RAINIER SQUARE REDEVELOPMENT RECOMMENDATION MEETING

Design Review Submittal # 2

Address: 1301 5th Ave., Seattle, WA 98101

DRB #2 Review Date: June 23, 2015

A.1 Major Scoop - DRB # 2 Proposed (Level 7)

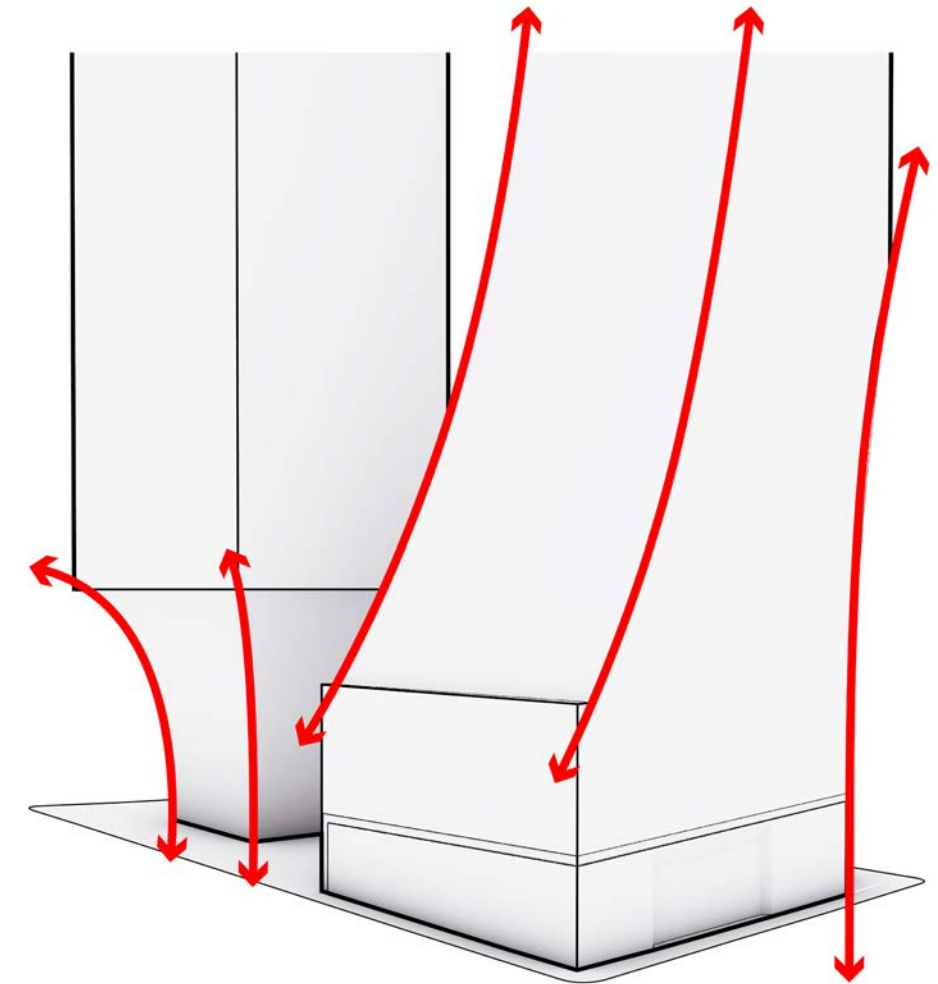
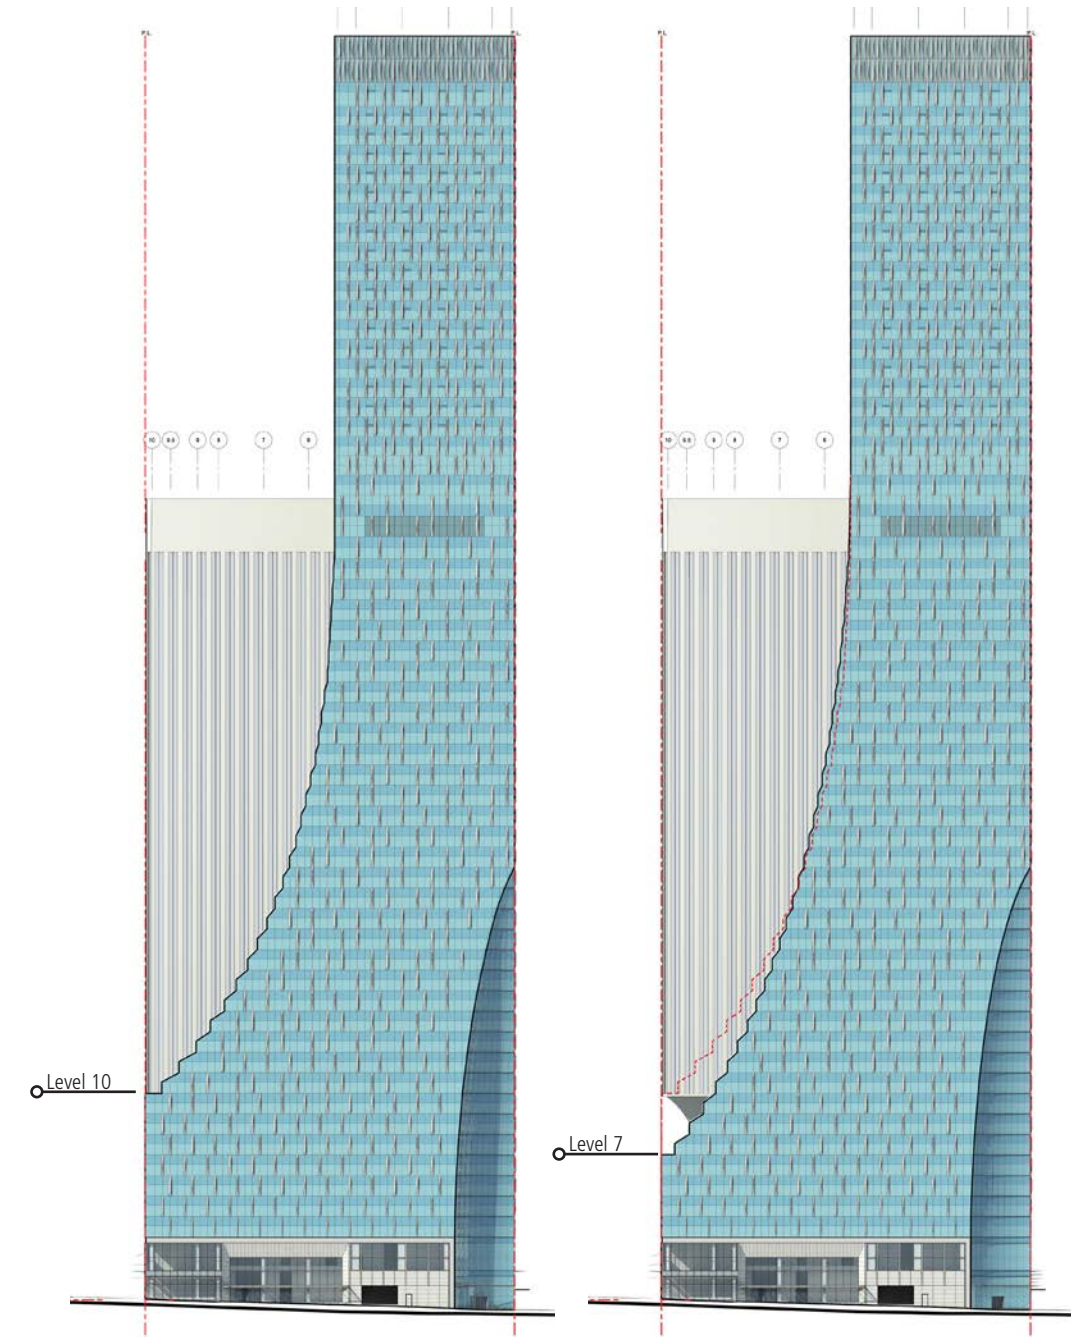
The Board continued to question the use of the top edge of the Rainier Tower plinth as a datum line to determine where the proposed tower's dominant curve begins its upsweep. The curved portion of the proposed building mass disassociates itself from Rainier Tower because its height above the datum line fails to engage with the base of the existing tower. Beginning the swoop lower allows the opposing concave curves to form an interesting visual dialogue as they intersect one another from a perspective north or south of the two structures. The Board sees this change in the scoop as beneficial to the tower's proportions and will preserve much of the existing view to Rainier Tower. A setback along Fifth may not be needed if the geometry of the curve opens up the views to the tower.

- A number of revisions to the datum elevation along 5th Avenue have been considered as well as its relationship to the existing Rainier Tower and the spring point for the dominant curve in the new tower.
- The proposed alternative lowers the datum elevation to level 7 (previously level 10), allowing a more dynamic visual dialogue between the opposing concave curves of the two structures as viewed from the south and the north along 5th Avenue.

- 5th Avenue façade datum has been significantly lowered to better engage the geometry of the two towers while maintaining a dynamic curve above the 7th floor.
- Proportional massing of the street wall at the base and its relationship to the urban context is improved.

B.1 Southeast Carve

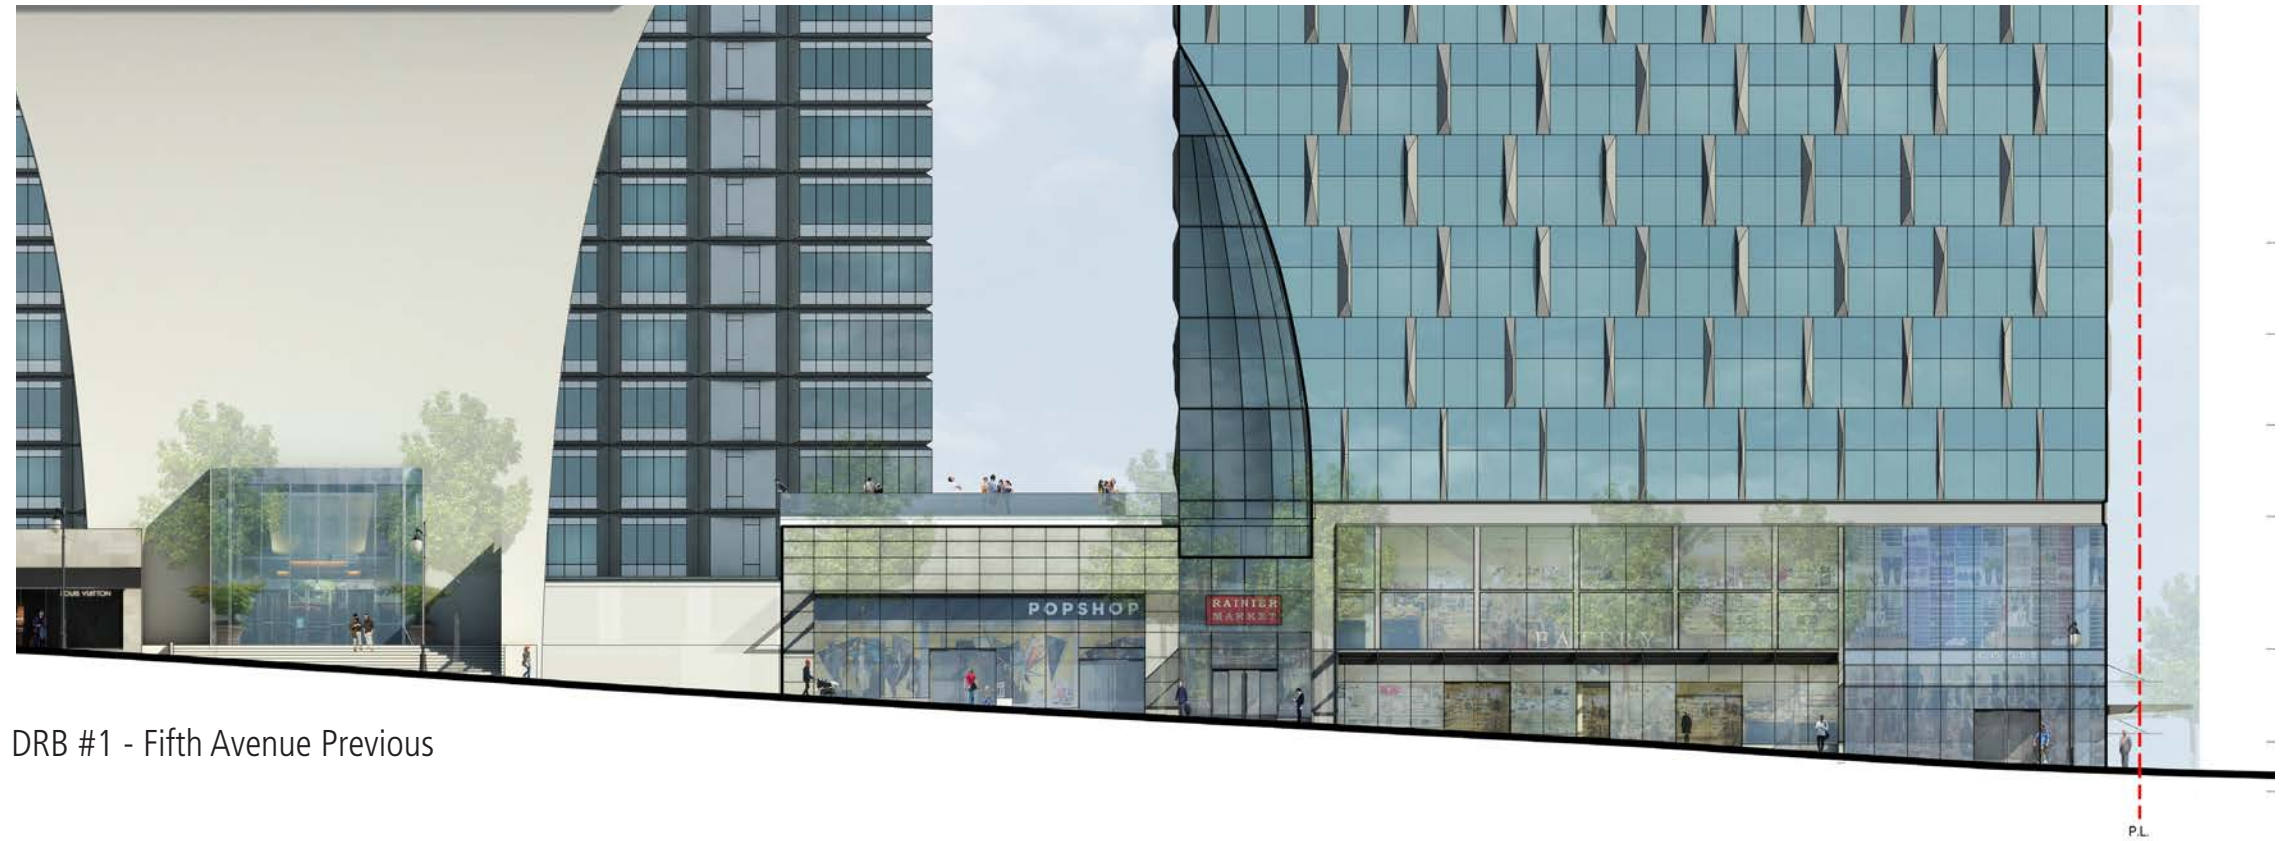
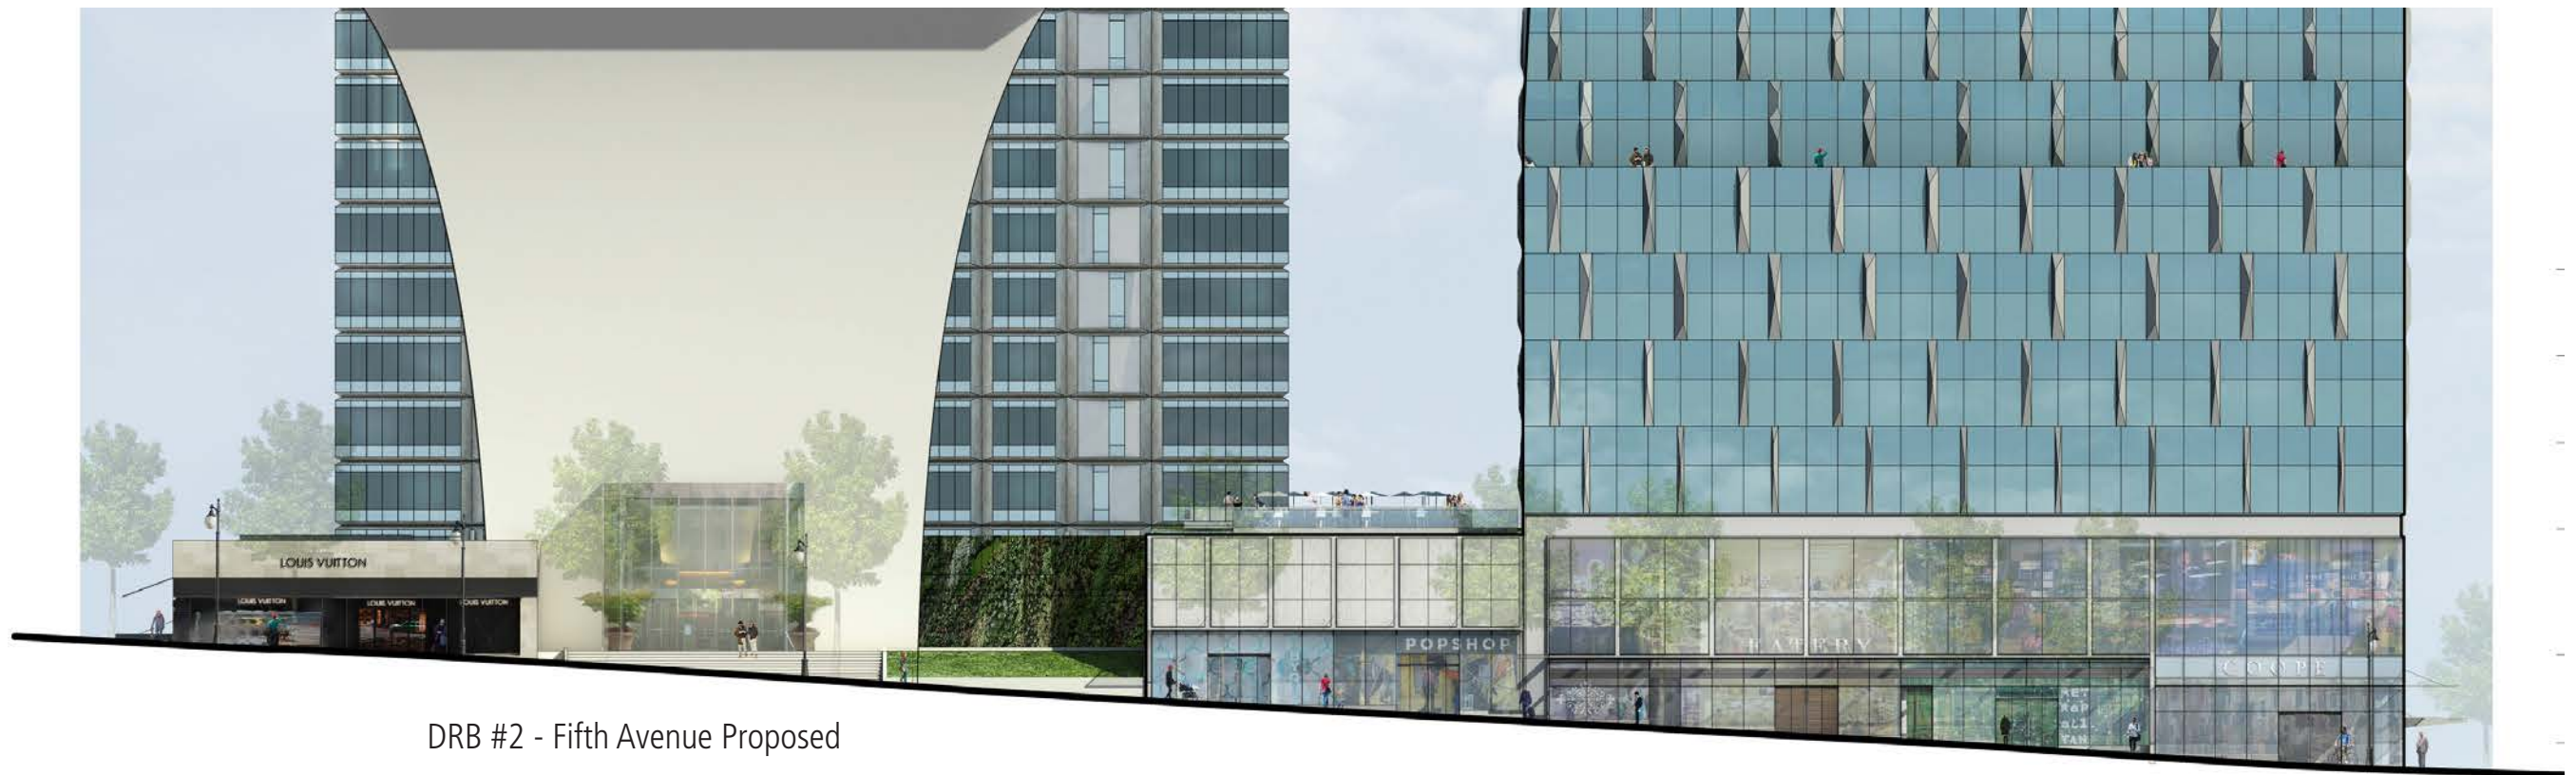
The Board, after reviewing four alternative studies of the terraced east wall, agreed that the applicant's preferred accordion like pleats or folds forming the outer skin of the prevailing scoop met its expectation. The angled metal panels, scattered along the other facades, would fold along with the angled glazing. The pleats and the projecting metal panels would provide a texture beyond that of a smooth slope as illustrated in Study #4.

While commending the revised corner elevations at Fifth and Union, the Board found the applicant's attempt to carve into the tower's southeast corner unsatisfactory as it breaks the predominant datum line above the two-story retail base. The presence of the southeast scoop pales in contrast to the dramatic lift expressed by the Rainier Tower base.

- The southeast carve has been eliminated as requested by the Board in order to strengthen the massing composition at the base and its relationship to the new tower.
